Williams Aviation Consultants

Williams Aviation Consultants, Inc. comments on The FAA Initiative to Address Noise Concerns of Santa Cruz/Santa Clara/San Mateo/San Francisco Counties and The Mountain SERFR proposal. January 29, 2016

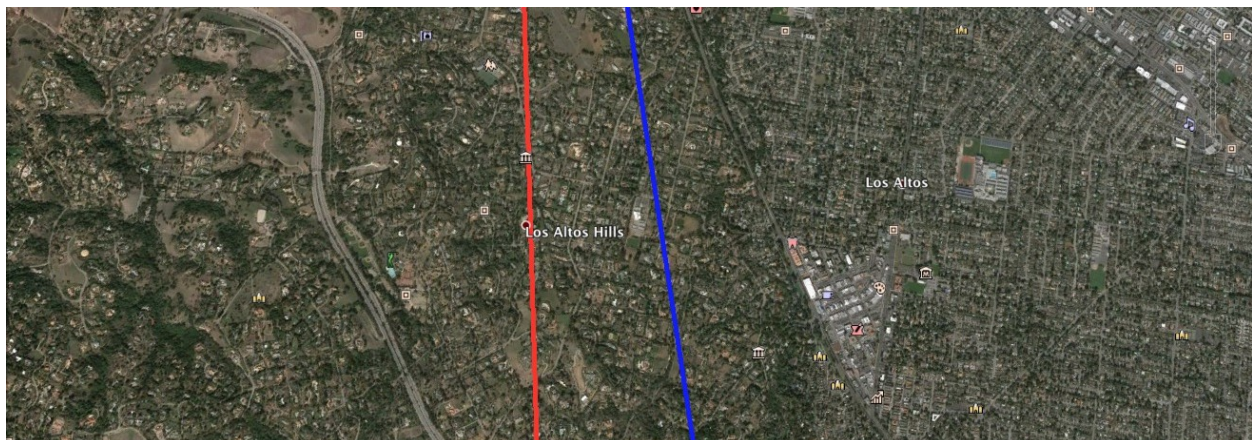
The proposed SERFR Arrival moves the flight path west approximately 3.5 miles at the shoreline near Santa Cruz. The route then proceeds directly to the current MENLO intersection. The proposal also anticipates a significant increase in aircraft altitude along the route. The altitude at MENLO would be approximately 1,000 feet higher than that contained in the current procedure. As part of this proposal, it is recommended that the BRIXX Arrival to SJC be routed north of its current track and the altitude raised to remain above the proposed SERFR Arrival. The increased altitudes on the SERFR and BRIXX arrivals offer the potential of some noise relief to the residents of Los Altos Hills. Unfortunately the revised procedure moves the new flight track directly over Los Altos Hills. In the figure below, the red line shows the proposed SERFR Arrival while the blue line depicts the current procedure.

It is doubtful that the proposed change would alter or diminish the noise from SFO arriving aircraft to any significant degree. The current use of the airspace over Los Altos Hills as the preferred area to blend the various arrival flows into the required single stream of aircraft landing at SFO is the primary source of the existing noise problem. The increase in the altitude on the BRIXX Arrival to SJC offers the possibility of substantial noise reduction along that route.

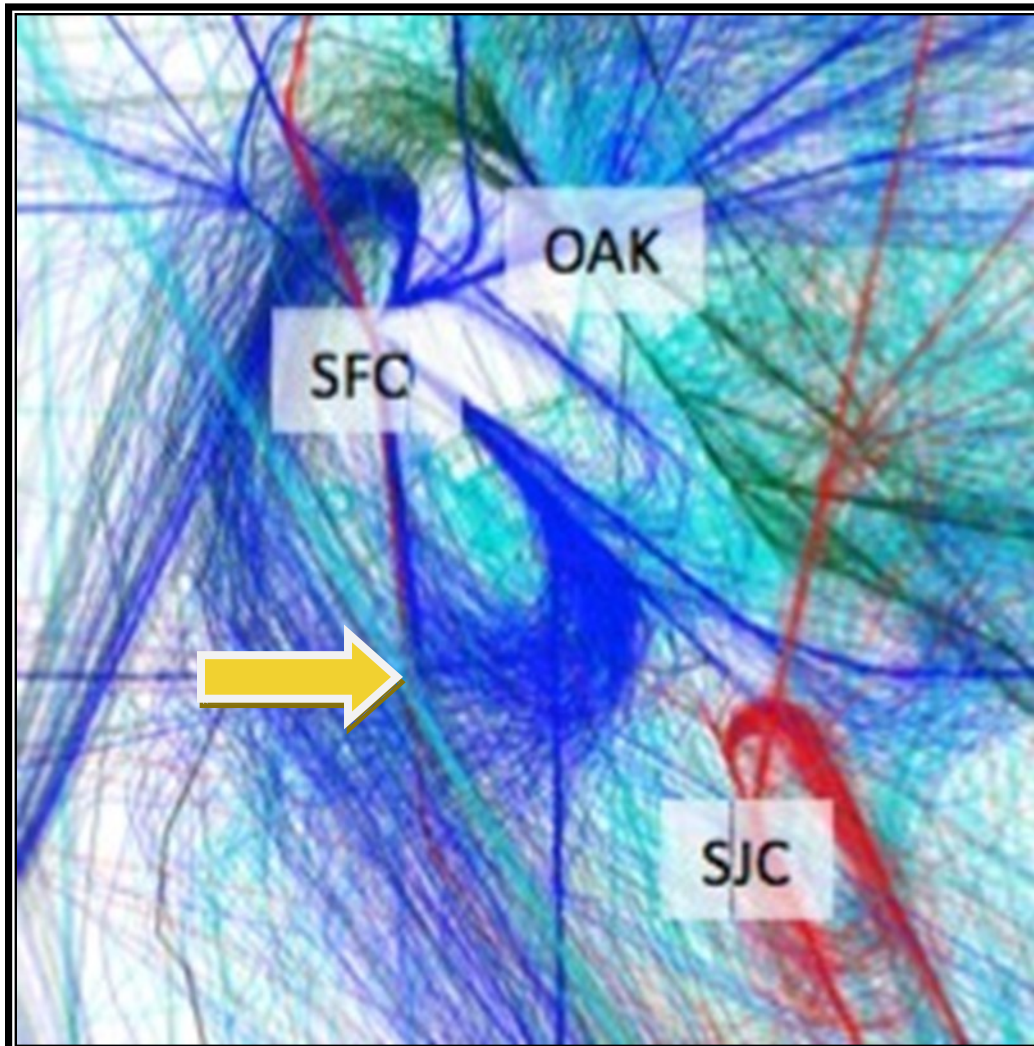
In the following graphic the blue teardrop shape extending from SFO southeastward towards SJC are the radar tracks of aircraft landing at SFO from departure airports in the north and northwest via the west leg of the Pt Reyes route. It is these aircraft along with the aircraft inbound on other routes (SEFER, Oceanic Arrivals as well as aircraft inbound from the east during poor weather conditions) that are placed on delaying radar vectors and sequenced with those inbound from the north that cause the greatest disruption to Los Altos Hills residents. This is also where the

greatest benefit can be obtained by direct dialog between community representatives and FAA ATC personnel.
